AMENDMENT OF SOLICITATION/MODIFICATION OF CONTRACT				1. CONTRACT ID CODE J		PAGE OF PAGES 1 2	
2. AMENDMENT/MODIFICATION NO. 0001		3. EFFECTIVE DATE 29-Jan-2006		4. REQUISITION/PURCHASE REQ. NO.		5. PROJECT NO.(If applicable)

14. DESCRIPTION OF AMENDMENT/MODIFICATION (Organized by UCF section headings, including solicitation/contract subject matter where feasible.) The above numbered solicitation for Hurricane Repairs and Modifications I.H.N.C. East Side Lock to North Claiborne Avenue is modified to Change an existing drawing and clarify questions addressed by the contractor. See attached sheet and drawing. The date and hour for receipt of proposal package is changed to Tuesday 31 January 2006, 10:00 A.M. Central time. All other terms and conditons remain unchanged. Except as provided herein, all terms and conditions of the document referenced in Item 9A or 10A, as heretofore changed, remains unchanged and in full force and effect.							
15A. NAME AND TITLE OF SIGNER (Type or print)				16A. NAME AND TITLE OF CONTRACTING OFFICER (Type or print)			
				TEL: _____ EMAIL: _____			
15B. CONTRACTOR/OFFEROR _____ (Signature of person authorized to sign)		15C. DATE SIGNED		16B. UNITED S

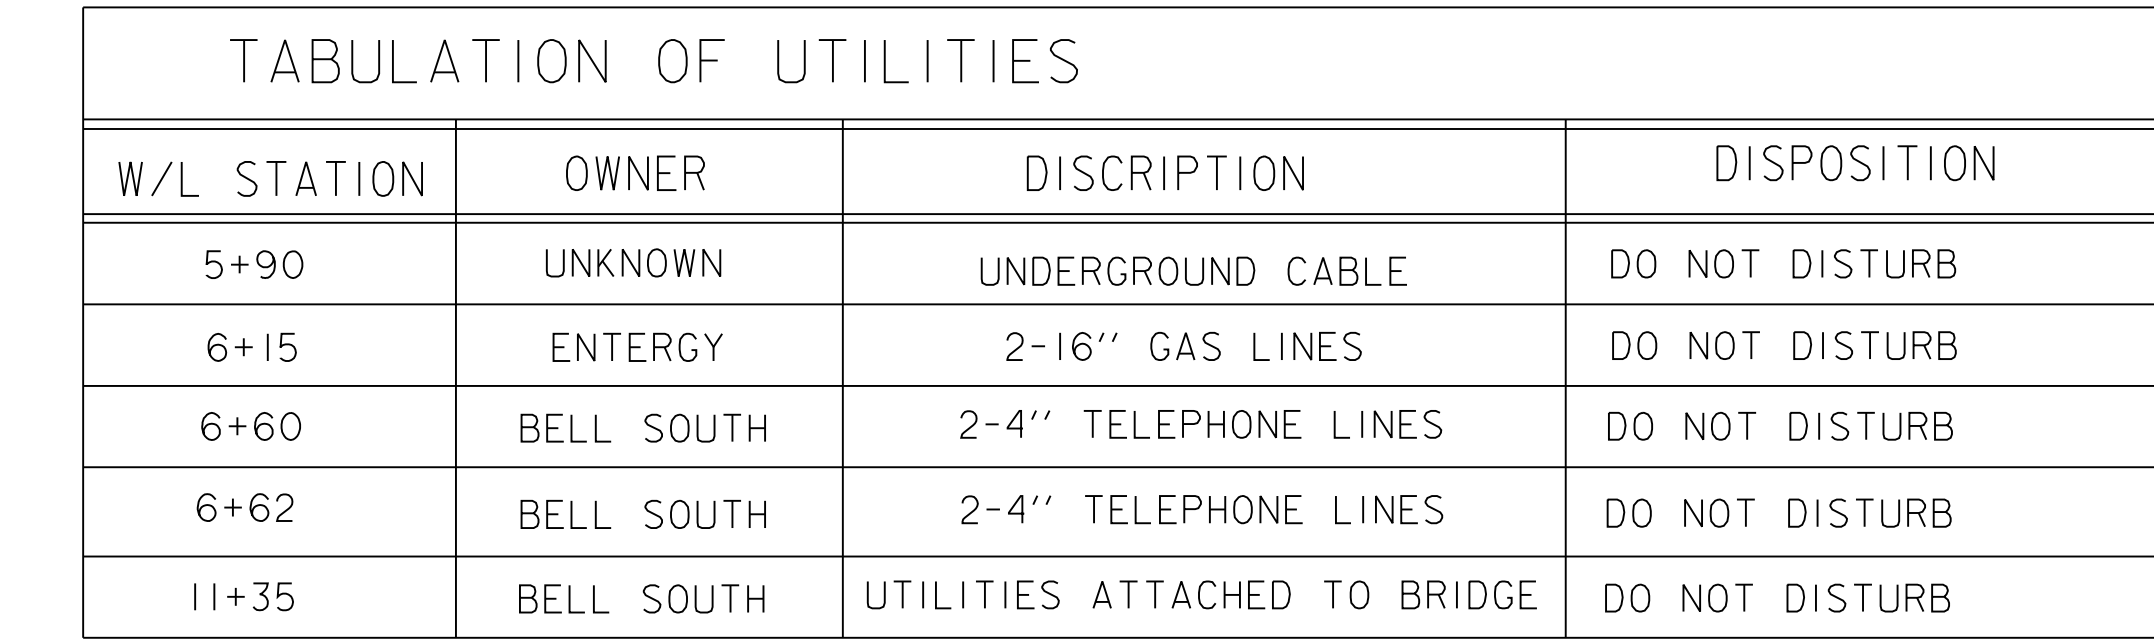
2. There is a cross hatched area (310'X45') shown on sheet 2 of 5 noted required ROW. What does the cross hatching represent? What work, if any, is required in this area?

The area is currently being obtained by our Real Estate Division. The work in the area will include clearing and grubbing and removing debris as described in Specification Section 02231. There are two abandoned vehicles in this area that will be moved to the existing ROW on the south side of the Claiborne bridge, as shown on amended Drawing 2 (attached).

The only change to drawings for this amendment will be to delete current Drawing 2 and substitute with amended Drawing 2, dated 1/29/06.
